ADDENDUM NO. 2

To: All prospective Bidders
DCR Contract #P24-3541-C1A
Lowe's Pond Dam Rehabilitation

Date: October 17, 2024

PROJECT
MASS DCR
ABANDONED DAMS
LOWES POND DAM
CONTRACT NO.
P19-3264-D4A

10 C-105

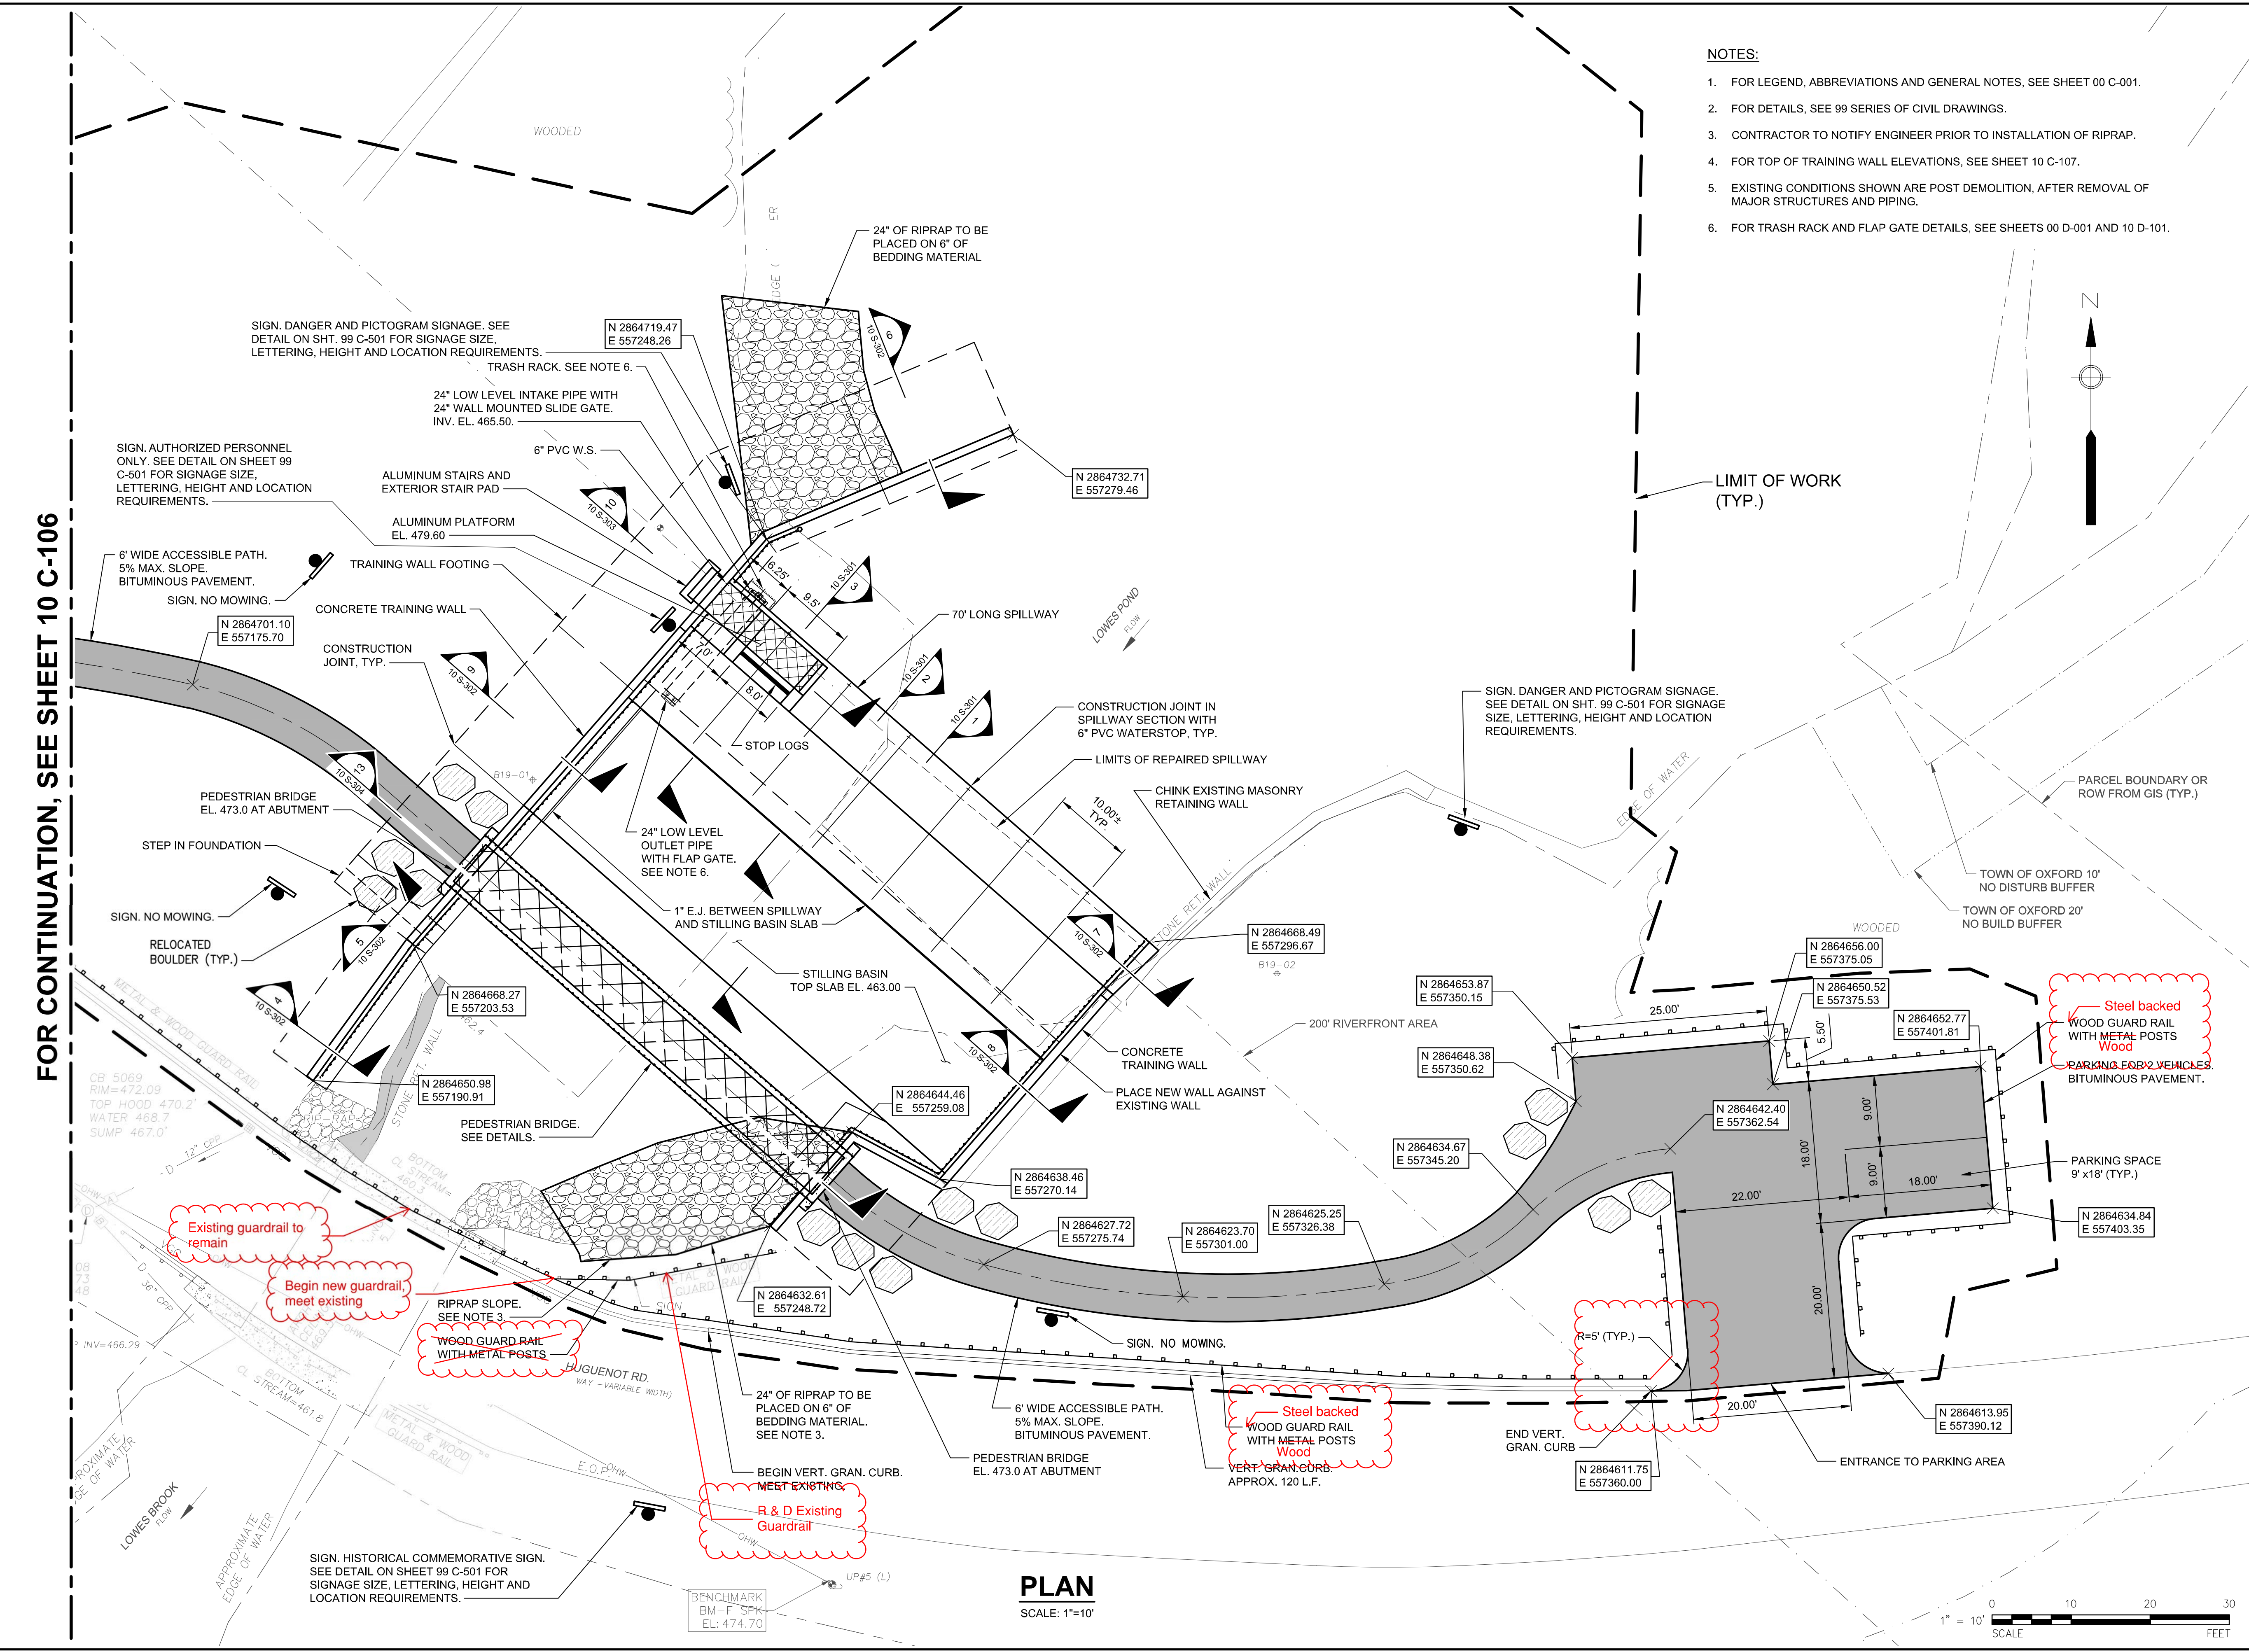
16. Drawings C-105 & C-106 describe the wood guardrail as having metal posts. However, the details on Drawing C-507 show timber posts. Please clarify which type of post is required.

22. On the new guardrail being installed the detail seems to contradict what the plans are saying. The site layout plan C-105 and C-106 call out for wood guardrail with steel post which is what is out on site currently. The detail on C-507 shows steel backed guardrail with wood posts and detail C-508 shows a steel guardrail with wood post.

AECOM Response: Timber posts are required.

AECOM Response: Steel backed wood guardrail with wood posts is correct as shown on C-507. Callouts on Drawings C-105, C-106, C-107, C-108, C109 and C-110 are being

revised with this addendum. This addendum is removing sheets C-506, C-508, C-509 and C-510 to eliminate contradiction.

99 C-508

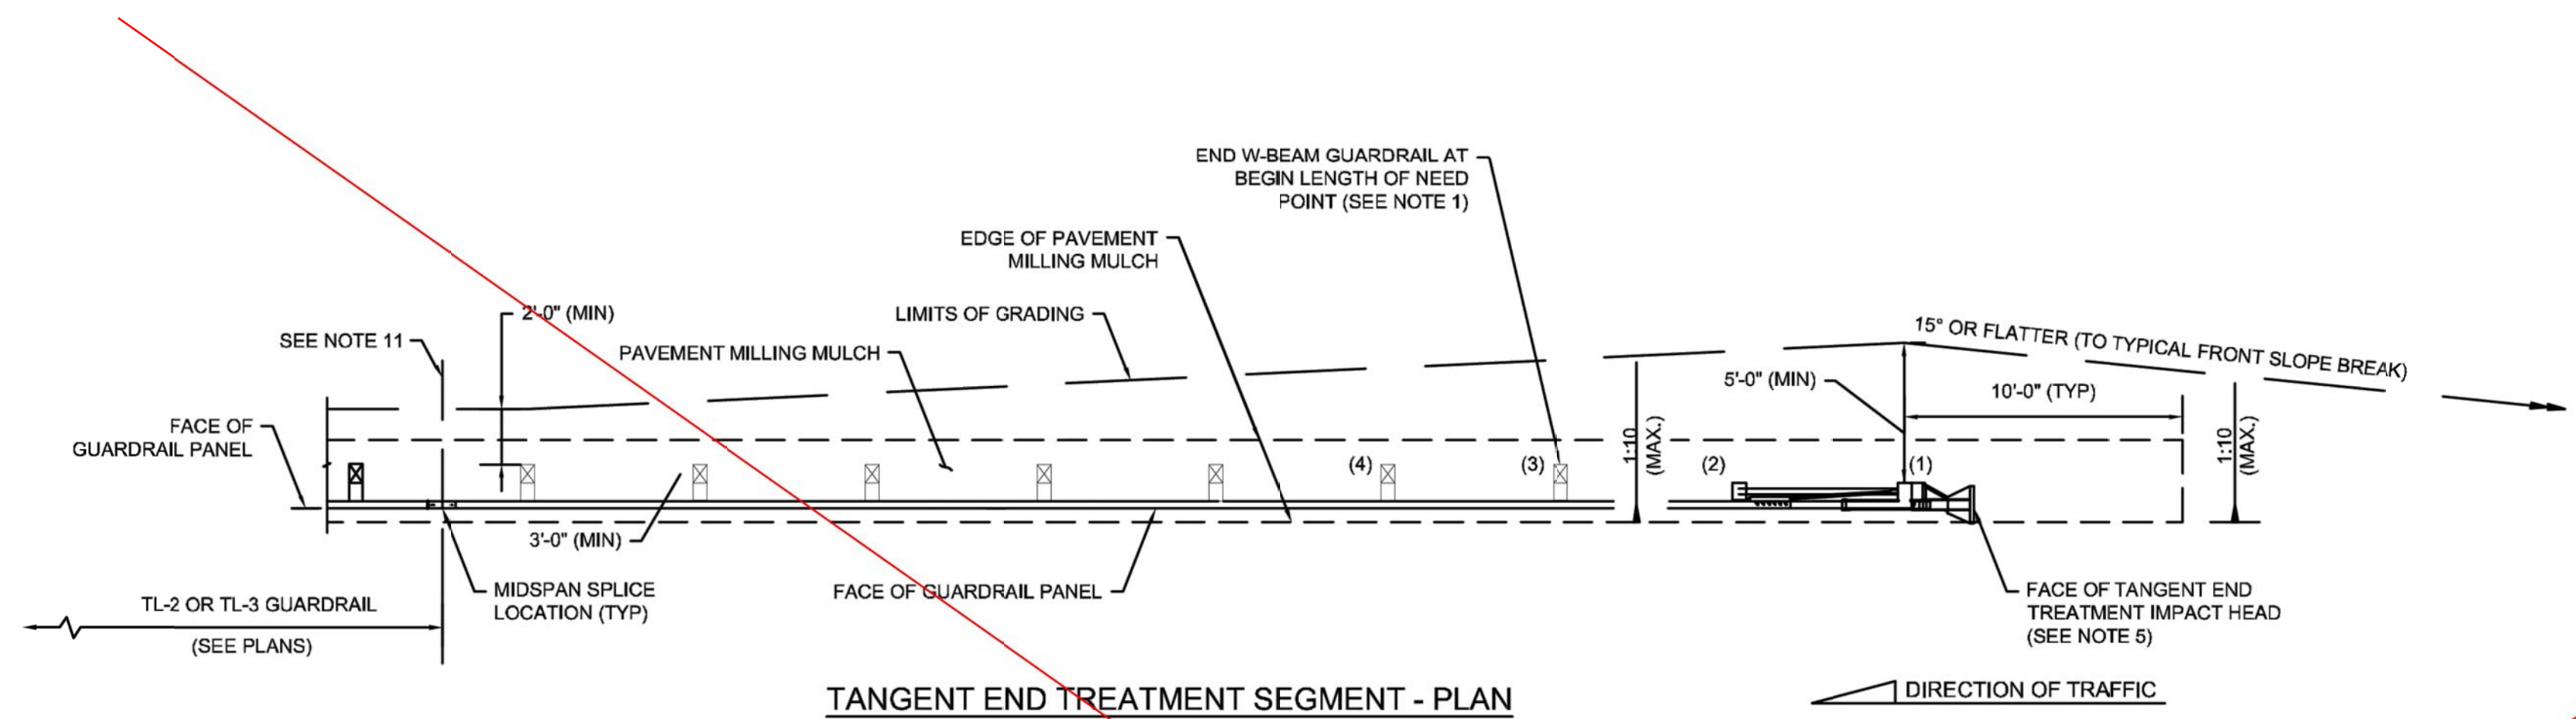
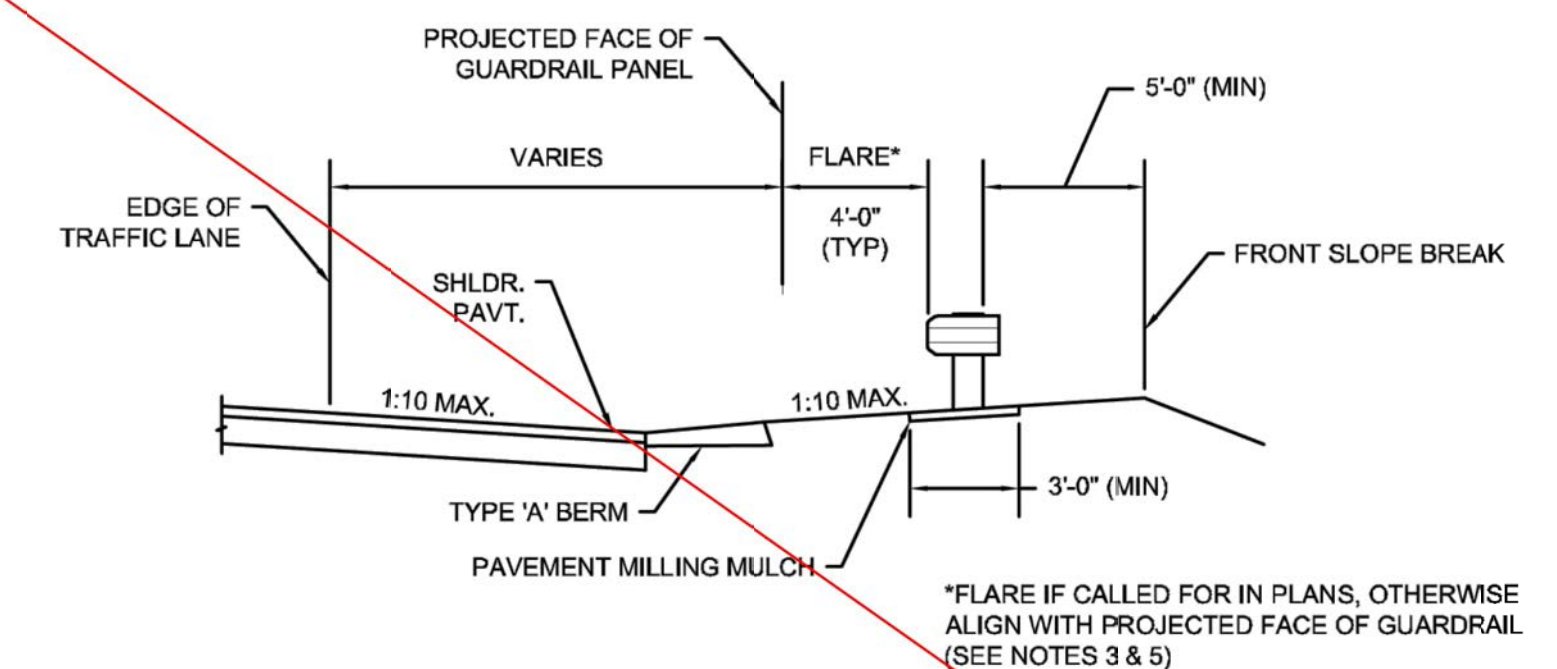
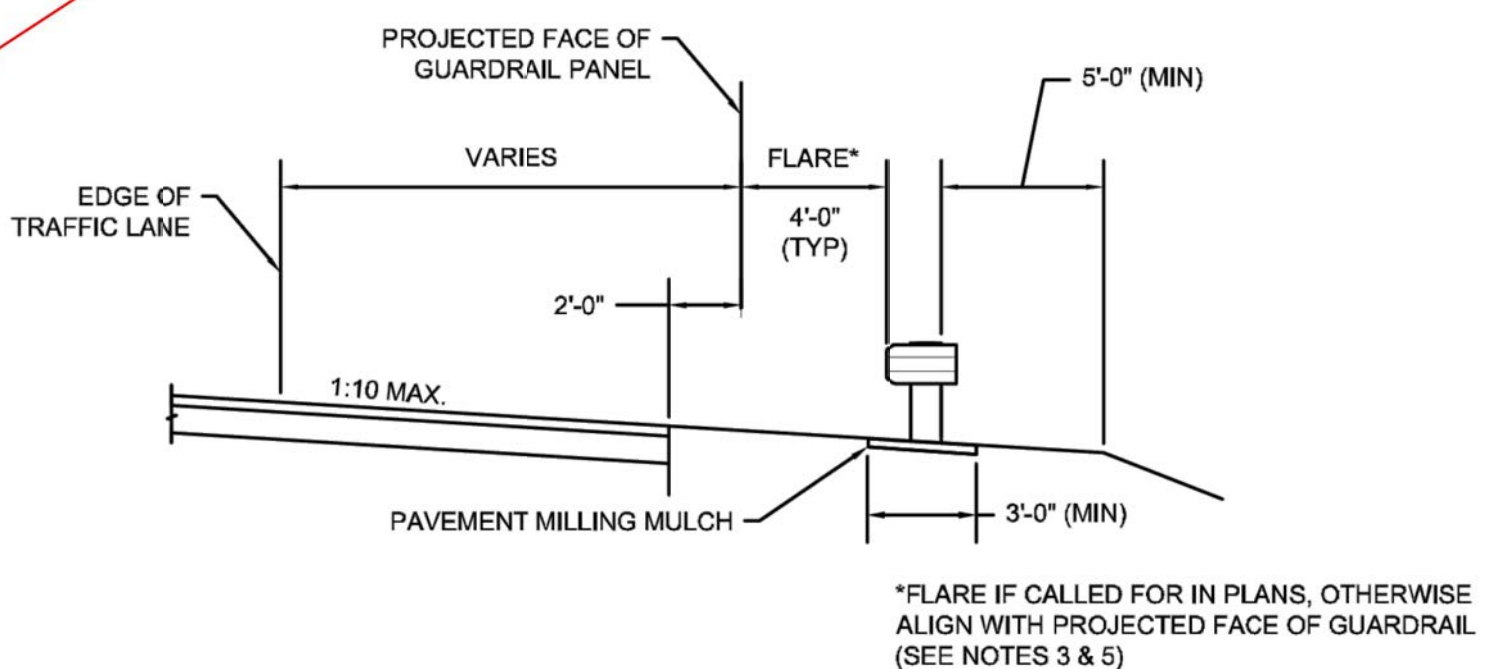
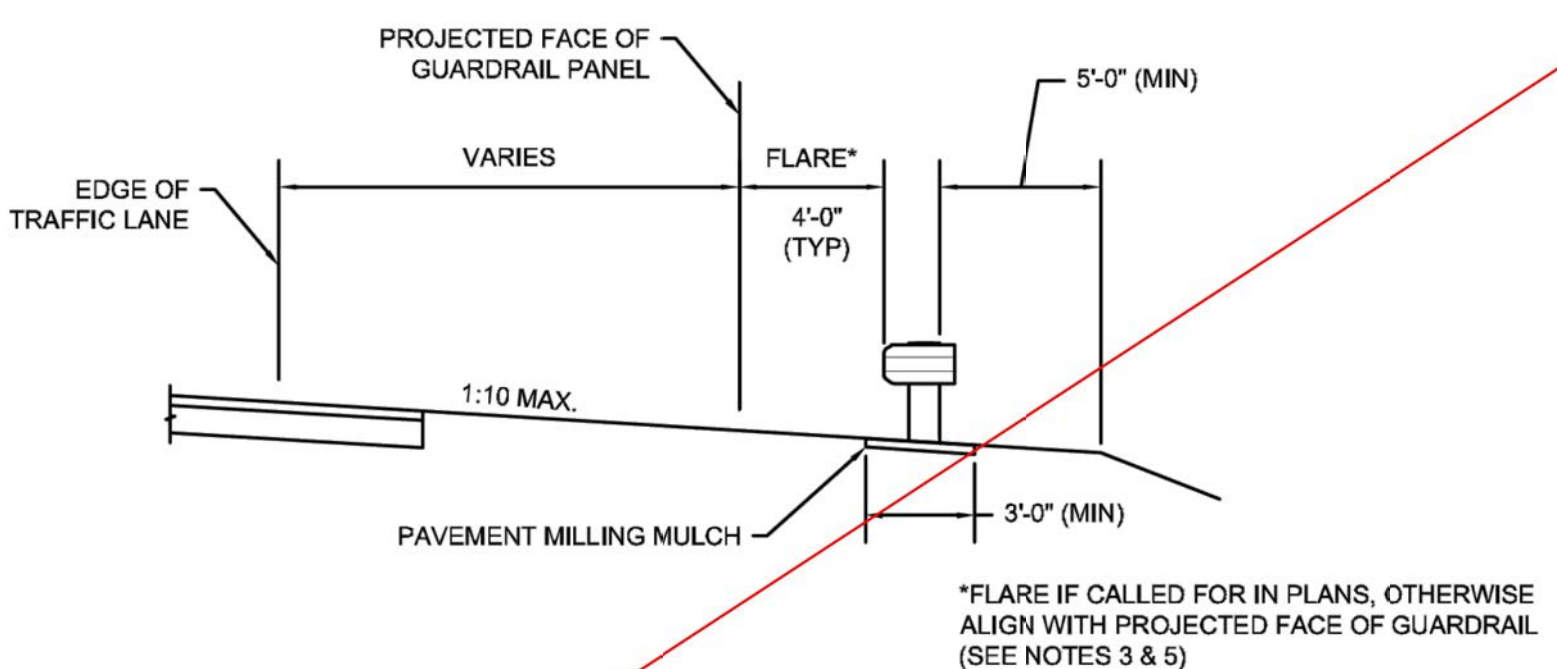
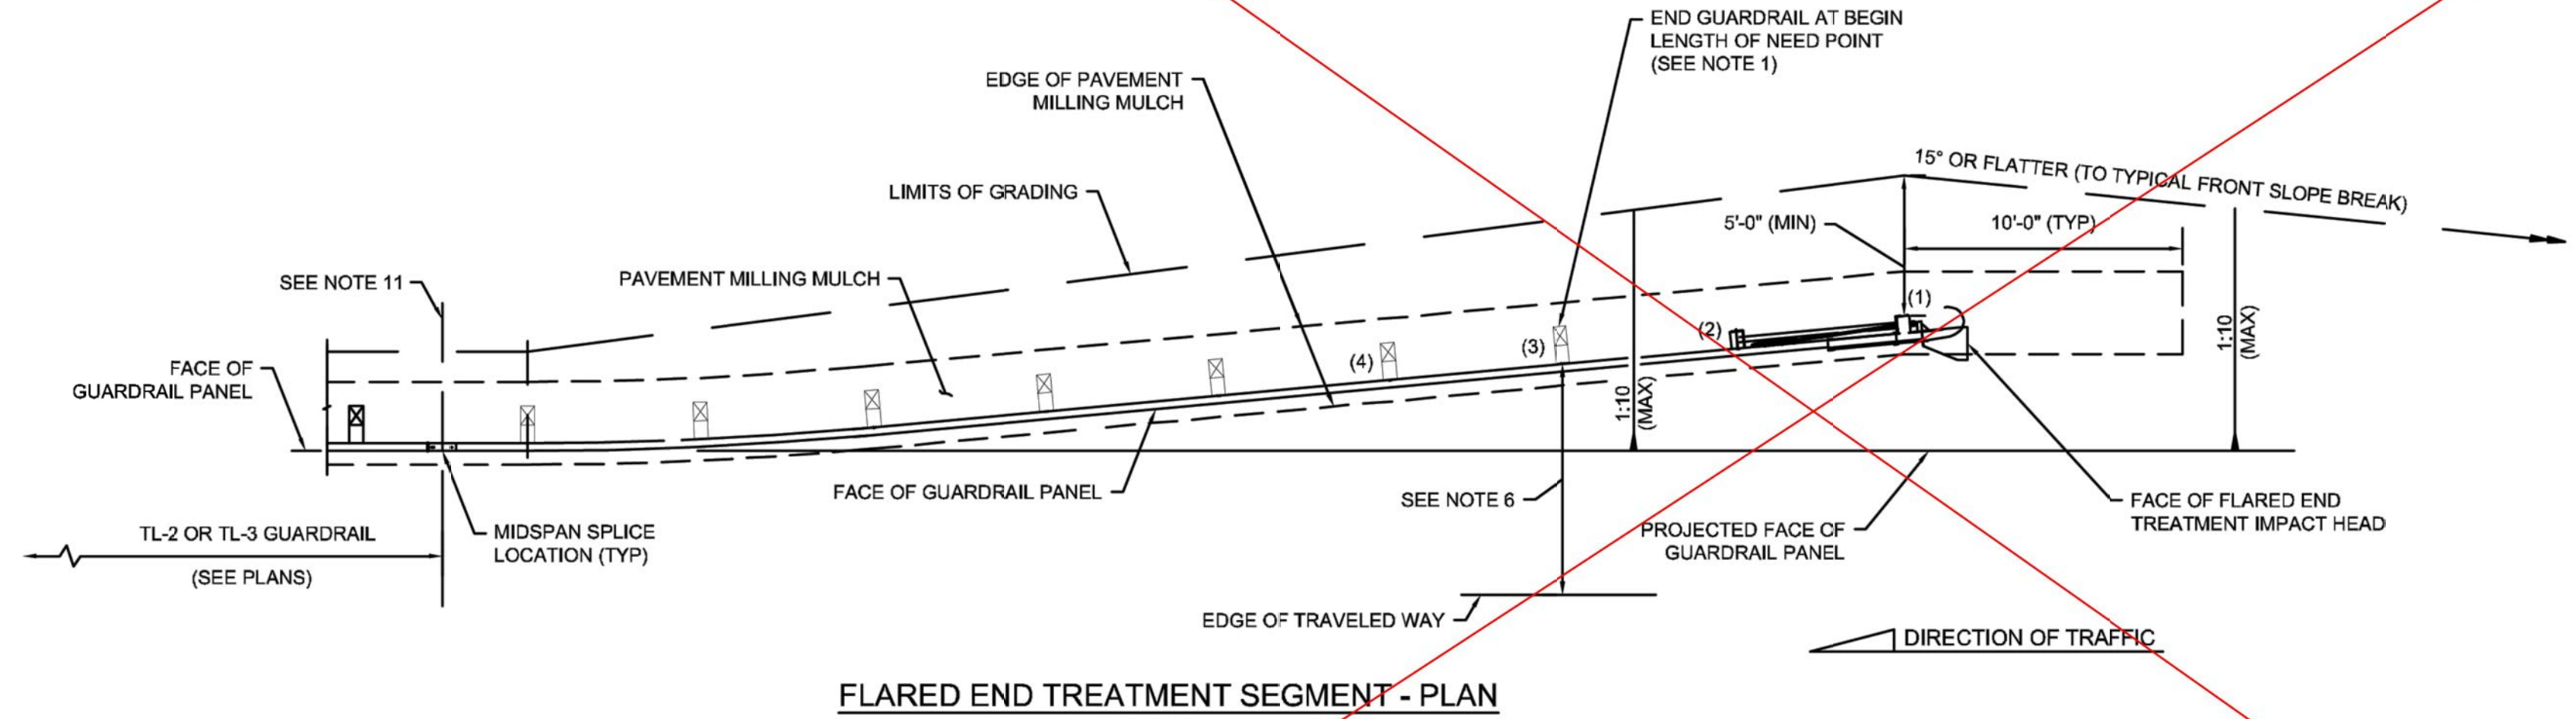
24. End terminal details on sheets 99 c-508, 99 c-509 show terminals that are compatible to a W-beam guardrail system. Proposed guardrail is steel backed timber guardrail . These are 2 totally different systems – please clarify. Due to the type of guardrail installation on this project end terminals are not warranted. Low speed traffic and parking spaces. please confirm.

AECOM Response: End terminals are not warranted.
